# Access Audit Site Report

**Franklin Mountains State Park  
Tom Mays Unit  
El Paso, TX 79911  
Accessibility Evaluation  
Inspection Date: 10/19/2022  
Inspectors: Tanya Scheibe**

Prepared By  
**WT Group**

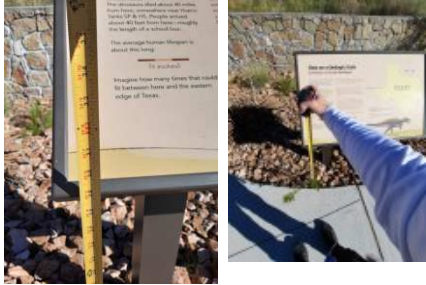
Finding Number	Area Description	Lat/Long	Finding	As Built	Recommendation	Citation	Photos	Figure
12	Headquarters/Visitor's Center: HQ - Exterior Accessible Route	[31.91042, -106.5184]	Element meets all standards and requirements	Curb ramp at accessible parking complies, curb ramp to sign complies	None	2010 ADAS Section: N/A		
13	Headquarters/Visitor's Center: HQ - Exterior Accessible Route	[31.9104234, -106.5182451]	The ramp does not have compliant handrails. Handrails are required on both sides of all surfaces that are sloped greater than 5 percent (1:20). Handrails must be between 34 inches and 38 inches above the ramp surface, must extend beyond the top and bottom of the ramp 12 inches and be parallel to the floor or ground surface. The diameter of the handrails must be between 1 inches and 2 inches in cross-sectional nominal dimension for circular handrails and handrail gripping surfaces with a non-circular cross section shall have a perimeter dimension of 4 inches minimum and 6 inches maximum, and a cross-section dimension of 2 inches maximum. The clear space between handrails and walls must 1-1/2 inches minimum.	Main ramp to HQ - Lacks handrail on one side of top run	Install handrails that are rounded and/or extend to the ground, with handrail extensions and mounted 34" to 38" AFF.	2015 ABAAS Section: 505.1  2012 TAS Section: 505.1  2010 ADAS Section: 505.1

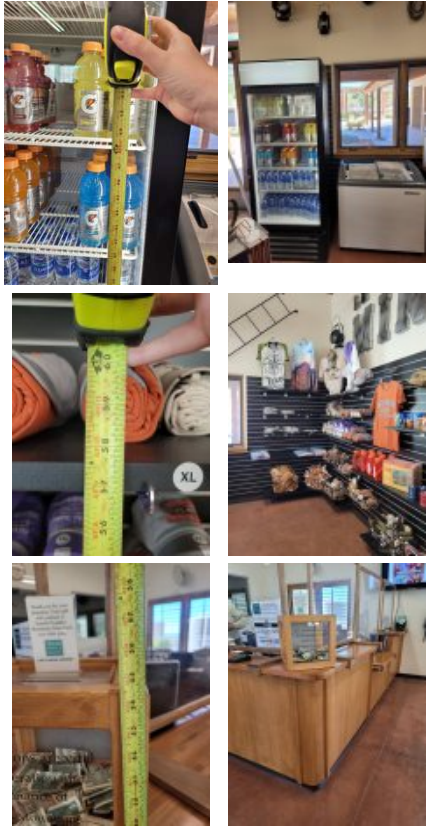
14	Headquarters/Visitor's Center: HQ - Exterior Accessible Route	[31.9103745, -106.518231]	The ramp slope exceeds the maximum running slope (direction of travel) allowable of 8.33%. Ramps should have the least possible slope but in no case more than 8.3% (1:12).	Main ramp to HQ - 8.8% running slope at top of first run from bottom, 8.5% at top by entry	Correct slope of ramp to max 8.33%.	2015 ABAAS Section: 405.2  2012 TAS Section: 405.2  2010 ADAS Section: 405.2

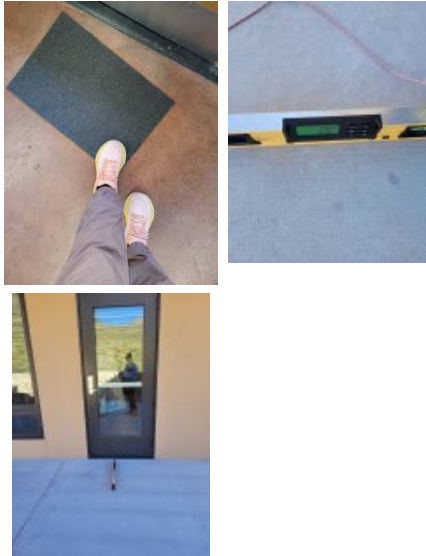
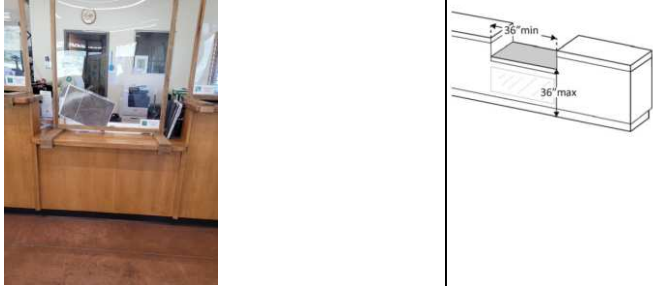
Finding Number	Area Description	Lat/Long	Finding	As Built	Recommendation	Citation	Photos	Figure
15	Headquarters/Visitor's Center: HQ - Public Spaces	[31.9105042, -106.5180766]	Element meets all standards and requirements	High bowl drinking fountain at Visitors Center restrooms complies	None	2010 ADAS Section: N/A		
16	Headquarters/Visitor's Center: HQ - Public Spaces	[31.9105054, -106.5180753]	The wheelchair accessible drinking fountain is noncompliant. Spout outlets shall be 36 inches maximum above the finish floor or ground and be located 15 inches minimum from the vertical support and 5 inches maximum from the front edge of the unit, including bumpers. The spout shall provide a flow of water at least 4 inches high minimum and shall be located 5 inches maximum from the front of the unit. The angle of the water stream shall be measured horizontally relative to the front face of the unit. Where spouts are located less than 3 inches of the front of the unit, the angle of the water stream shall be 30 degrees maximum. Where spouts are located between 3 inches and 5 inches maximum from the front of the unit, the angle of the water stream shall be 15 degrees maximum. On an accessible drinking fountain with a round or oval bowl, the spout must be positioned so the flow of water is within 3 inches of the front edge of the fountain.	Low bowl drinking fountain at Visitors Center restrooms inoperable, unable to audit	Ensure low bowl drinking fountain meets all requirements.	2015 ABAAS Section: 602.1 2012 TAS Section: 602.1 2010 ADAS Section: 602.1

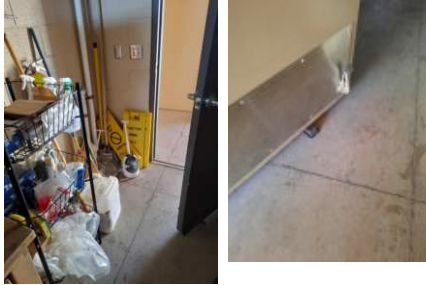
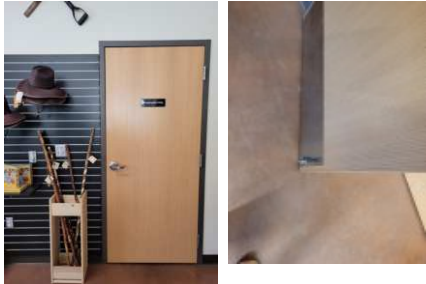
Finding Number	Area Description	Lat/Long	Finding	As Built	Recommendation	Citation	Photos	Figure
17	Headquarters/Visitor's Center: HQ - Public Spaces	[31.9105179, -106.5180713]	Element meets all standards and requirements	3 of 3 garbage cans at Visitor Center restrooms comply	None	2010 ADAS Section: N/A		
18	Headquarters/Visitor's Center: HQ - Public Spaces	[31.9105208, -106.518151]	Element meets all standards and requirements	4 of 4 wooden benches, shelf, and cabinet at Visitor Center comply	None	2010 ADAS Section: N/A		
19	Headquarters/Visitor's Center: HQ - Public Spaces	[31.9106401, -106.5179618]	Eyepieces on viewing scopes shall be 43 inches (1090 mm) minimum and 51 inches (1295 mm) maximum above the ground	Viewing scope at Visitors Center exceeds reach range - 57" above ground level (AGL)	Lower eyepiece on viewing scope to min 43" and max 51"; in the alternative, add a second scope that meets the standard as a smart practice.	2015 ABAAS Section: 1011.8

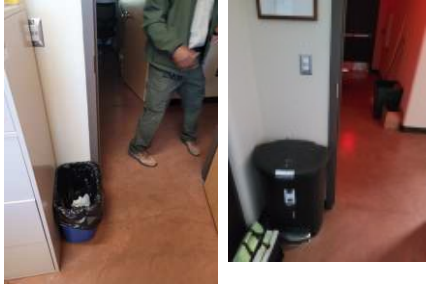
Finding Number	Area Description	Lat/Long	Finding	As Built	Recommendation	Citation	Photos	Figure
22	Headquarters/Visitor's Center: HQ - Public Spaces	[31.91059, -106.518]	Visual characters shall be 40 inches (1015 mm) minimum above the finish floor or ground. EXCEPTION: Visual characters indicating elevator car controls shall not be required to comply with 703.5.6.	"Time on geologic scale" info sign at Visitor Center is low	Remount signage to min 40" AFF as a smart practice.	2015 ABAAS Section: 703.5.6, 703.5.6 EXCEPTION  2012 TAS Section: 703.5.6, 703.5.6 Exception  2010 ADAS Section: 703.5.6, 703.5.6 Exception		
23	Headquarters/Visitor's Center: HQ - Public Spaces	[31.9106192, -106.5180543]	The operable part is not accessible because there is not adequate clear floor space for either a forward or side approach. The clear floor or ground space shall be 30 inches minimum by 48 inches minimum.	Clear floor space in front of drink cooler reduced to 39.75"	Remove, or relocate storage in CFS at fixtures and operable parts along the AR.	2015 ABAAS Section: 305.3  2012 TAS Section: 305.3  2010 ADAS Section: 305.3

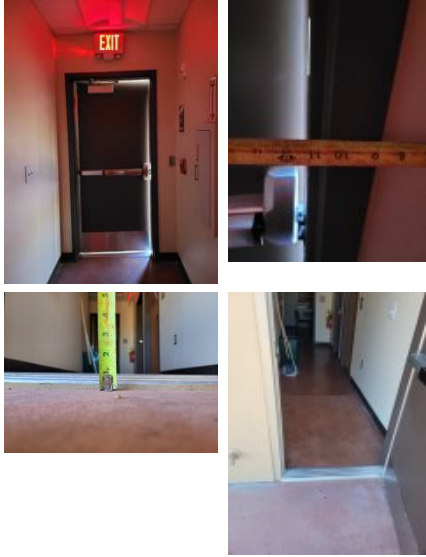
Finding Number	Area Description	Lat/Long	Finding	As Built	Recommendation	Citation	Photos	Figure
30	Headquarters/Visitor's Center: HQ - Employee Spaces	[31.9106323, -106.5180834]	Spaces and elements within employee work areas shall only be required to comply with 206.2.8, 207.1, and 215.3 and shall be designed and constructed so that individuals with disabilities can approach, enter, and exit the employee work area. Employee work areas, or portions of employee work areas, other than raised courtroom stations, that are less than 300 square feet (28 m2) and elevated 7 inches (180 mm) or more above the finish floor or ground where the elevation is essential to the function of the space shall not be required to comply with these requirements or to be on an accessible route.	Park superintendent office - clearance on pull side reduced by garbage	For employee spaces, relocate storage, furniture, and other obstacles at doorways to provide approach, enter and exit at the employee space. Provide required maneuvering clearance on push and pull side of doors.	2015 ABAAS Section: F203.9 2012 TAS Section: 203.9 2010 ADAS Section: 203.9

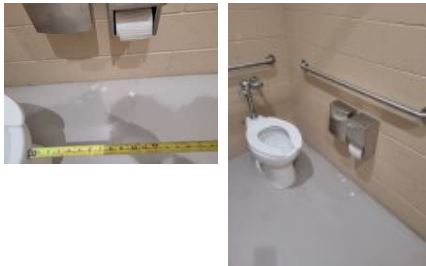
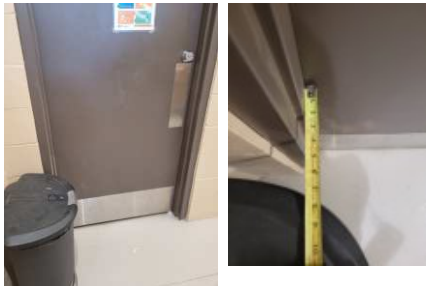
Finding Number	Area Description	Lat/Long	Finding	As Built	Recommendation	Citation	Photos	Figure
42	Headquarters/Visitor's Center: HQ - Employee Spaces	[31.9105993, -106.5181153]	The route of travel at this location does not provide a minimum width of 36 inches. The clear width shall be permitted to be reduced to 32 inches minimum for a length of 24 inches maximum provided that reduced width segments are separated by segments that are 48 inches long minimum and 36 inches wide minimum.	Route in breakroom reduces to 21" and 19" around table due to storage	Relocate storage to widen AR to compliant 36" clear width.	2015 ABAAS Section: 403.5.1 2012 TAS Section: 403.5.1 2010 ADAS Section: 403.5.1		
43	Headquarters/Visitor's Center: HQ - Employee Spaces	[31.9106004, -106.5180834]	Spaces and elements within employee work areas shall only be required to comply with 206.2.8, 207.1, and 215.3 and shall be designed and constructed so that individuals with disabilities can approach, enter, and exit the employee work area. Employee work areas, or portions of employee work areas, other than raised courtroom stations, that are less than 300 square feet (28 m2) and elevated 7 inches (180 mm) or more above the finish floor or ground where the elevation is essential to the function of the space shall not be required to comply with these requirements or to be on an accessible route.	door from Office Manager to front desk - trash in pull side clearance	For employee spaces, relocate storage, furniture, and other obstacles at doorways to provide approach, enter and exit at the employee space. Provide required maneuvering clearance on push and pull side of doors.	2015 ABAAS Section: F203.9 2012 TAS Section: 203.9 2010 ADAS Section: 203.9

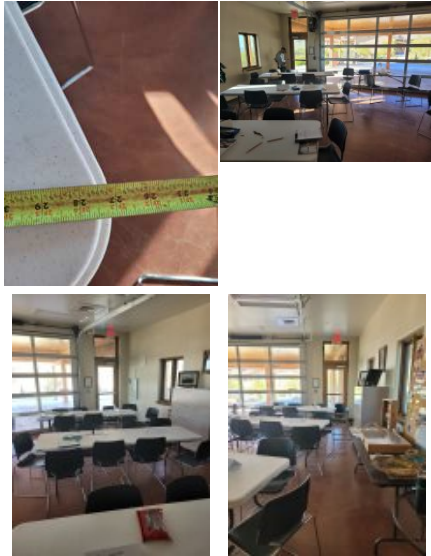
Finding Number	Area Description	Lat/Long	Finding	As Built	Recommendation	Citation	Photos	Figure
54	Interpretive Building: Interpretive - Exterior Accessible Route	[31.910103, -106.518074]	There is a gap spaced greater than a 1/2 inch. Openings in floor or ground surfaces shall not allow passage of a sphere more than 1/2 inch diameter. Elongated openings shall be placed so that the long dimension is perpendicular to the dominant direction of travel.	Two 1.25" gaps on mountain side of interpretive center	Correct or fill gaps to be max .5".	2015 ABAAS Section: 302.3 2012 TAS Section: 302.3 2010 ADAS Section: 302.3		
55	Interpretive Building: Interpretive - Exterior Accessible Route	[31.91647, -106.5145]	Element meets all standards and requirements	Steps at end of interpretive center comply (not a means of egress)	None	2010 ADAS Section: N/A		
56	Interpretive Building: Interpretive - Exterior Accessible Route	[31.91006, -106.5182]	Element meets all standards and requirements	Walkway in front of interpretive center complies	None	2010 ADAS Section: N/A

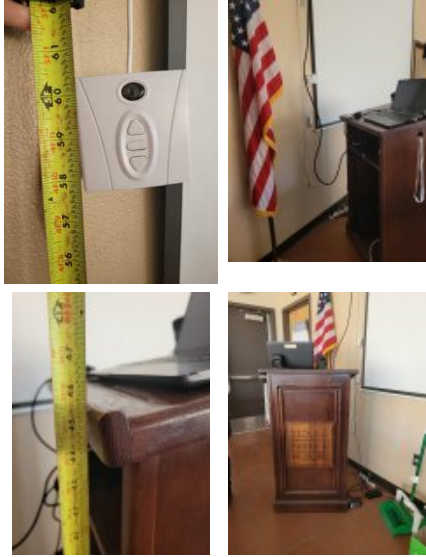
Finding Number	Area Description	Lat/Long	Finding	As Built	Recommendation	Citation	Photos	Figure
58	Interpretive Building: Interpretive - Public Spaces	[31.9101685, -106.5180249]	Fire building surfaces shall be 9 inches (230 mm) minimum above the ground.	Fire ring at interpretive center has fire building surface below the surrounding grade	Correct fire building surface to be 9" min above the ground as a smart practice. In the alternative, replace fire ring with a compliant accessible fire ring.	2015 ABAAS Section: 1011.5.1		
59	Interpretive Building: Interpretive - Public Spaces	[31.9102085, -106.5180659]	Visual characters shall be 40 inches (1015 mm) minimum above the finish floor or ground. EXCEPTION: Visual characters indicating elevator car controls shall not be required to comply with 703.5.6.	"Staying cool, staying hydrated" info sign at Interpretive Center is low	Remount signage to min 40" AFF as a smart practice.	2015 ABAAS Section: 703.5.6, 703.5.6 EXCEPTION  2012 TAS Section: 703.5.6, 703.5.6 Exception  2010 ADAS Section: 703.5.6, 703.5.6 Exception

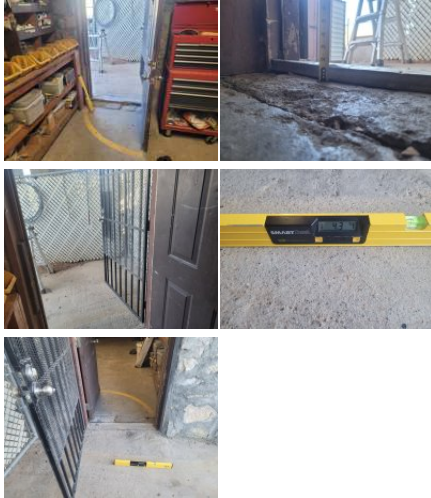
Finding Number	Area Description	Lat/Long	Finding	As Built	Recommendation	Citation	Photos	Figure
69	Interpretive Building: Interpretive - Public Spaces	[31.9101427, -106.5181868]	The operable part is positioned too high for either a side or front approach. Where a clear floor or ground space allows a parallel approach to an element and the side reach is unobstructed, the high side reach shall be 48 inches maximum and the low side reach shall be 15 inches minimum above the finish floor or ground. Where a forward reach is unobstructed, the high forward reach shall be 48 inches maximum and the low forward reach shall be 15 inches minimum above the finish floor or ground.	Controls for screen at 58" above the finished floor (AFF), podium screen controls at 45.5" AFF	Remount operable parts to be in reach range of 15" min to 48" max.	2015 ABAAS Section: 308.1  2012 TAS Section: 308.1  2010 ADAS Section: 308.1

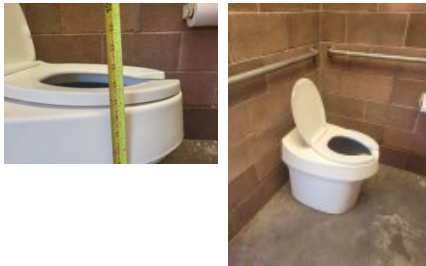
87	Restroom 1 Area: RR 1 - Picnic Areas	[31.9140264, -106.5167799]	The surface of the route to and into the picnic area or shelter must be firm and stable.	Loose gravel at transition from shelter walkway to accessible parking	Replace or correct surface to be firm and stable as a smart practice.	2015 ABAAS Section: 1016.1, 1016.1 EXCEPTION S 1, 1016.1 EXCEPTION S 2, 1016.1 EXCEPTION S 3

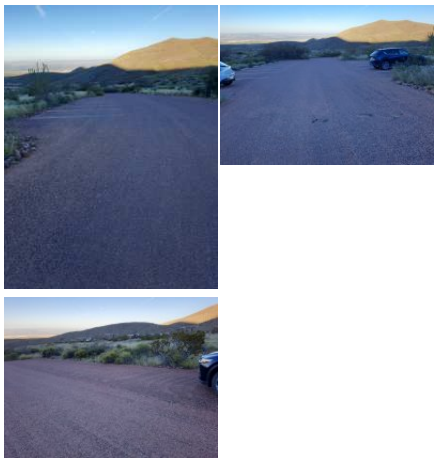
89	Restroom 1 Area: RR 1 - Picnic Areas	[31.91413, -106.5168]	Where picnic facilities contain two or fewer picnic units, each picnic unit shall provide mobility features complying with F245.2.	Lacks route to garbage can	Relocate garbage can at shelter or picnic area along an accessible route as a smart practice.	2015 ABAAS Section: F245.2.1		
90	Restroom 1 Area: RR 1 - Trailheads	[31.9140936, -106.5178912]	There is no accessible route to the the Lower Sunset Trailhead and bike tools. At least one accessible route shall connect accessible buildings, accessible facilities, accessible elements, and accessible spaces that are on the same site.	Lacks route to the Lower Sunset Trailhead and bike tools	Create an accessible route with crushed stone or other outdoor material from parking or walkway to the Lower Sunset Trailhead and bike tools.	2015 ABAAS Section: F206.2.2 2012 TAS Section: 206.2.2 2010 ADAS Section: 206.2.2

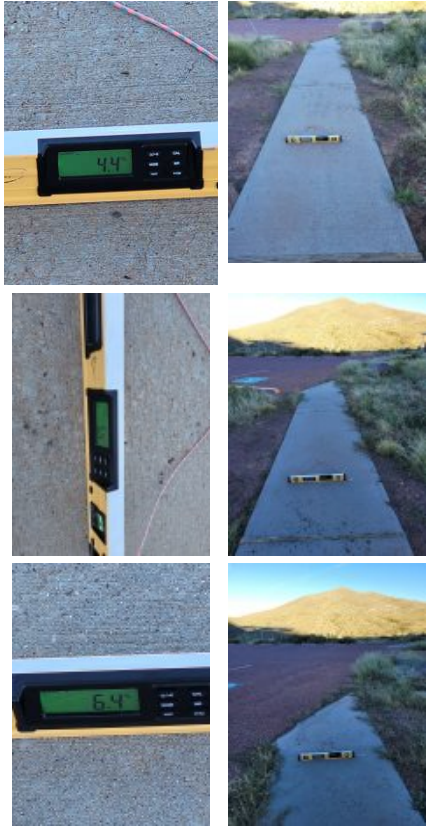
109	Restroom 2 Area: RR 2 - Parking	[31.9161285, -106.5137992]	The access aisle is missing at the accessible parking stall. Access aisles serving parking spaces shall adjoin an accessible route. Two parking spaces shall be permitted to share a common access aisle.	Restroom 2 picnic area upper parking -lacks access aisle	Repaint 8' accessible parking stalls, with one 5' adjacent access aisle, with proper signage and striping.	2015 ABAAS Section: 502.3.1 2012 TAS Section: 502.3.1 2010 ADAS Section: 502.3.1		
110	Restroom 2 Area: RR 2 - Parking	[31.916124, -106.5137966]	The cross slopes (narrow dimension) and/or running slopes (long dimension) of the access aisle exceeds 2%. The running slope and the cross slope in an accessible parking stall and the access aisle must not exceed 2%.	Restroom 2 picnic area upper parking - 8.2% slope in stall	Repair or correct slope of parking space and access aisle to max 2.08% in any direction.	2015 ABAAS Section: 502.4 2012 TAS Section: 502.4 2010 ADAS Section: 502.4

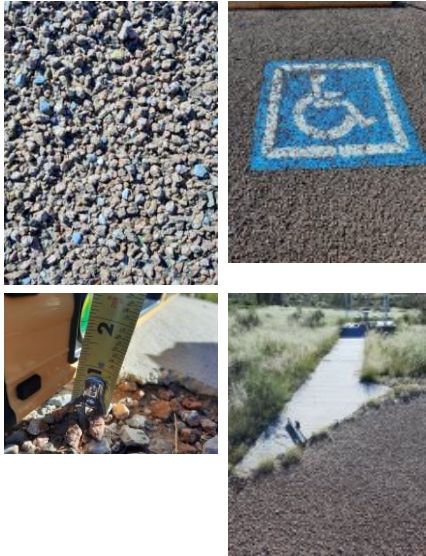
125	Restroom 2 Area: RR 2 - Single User Restroom	[31.916382, -106.51377 91]	The restroom sign does not comply with one or more applicable requirements for the location, height, and properties of the sign.	Lacks any signage, no ISA	Acquire and mount signage, including Braille, raised lettering and access symbol mounted on wall, latch side of door, 48" to baseline of lowest character and 60" to baseline of highest character.	2015 ABAAS Section: F216.2, 703.1, 703.2, 703.5, 703.6  2012 TAS Section: 216.2, 703.1, 703.2, 703.5, 703.6  2010 ADAS Section: 216.2, 703.1, 703.2, 703.5, 703.6		
126	Restroom 2 Area: RR 2 - Single User Restroom	[31.9163729 , -106.5137 764]	The toilet seat is not located within the range allowed off the floor. The height of accessible water closets shall be a minimum of 17 inches and a maximum of 19 inches measured to the top of a maximum 2-inch high toilet seat.	Seat at 19.5" above the finished floor (AFF)	Replace toilet seat, or re-set or replace toilet to 17" to 19" above the finished floor (AFF).	2015 ABAAS Section: 604.4  2012 TAS Section: 604.4  2010 ADAS Section: 604.4
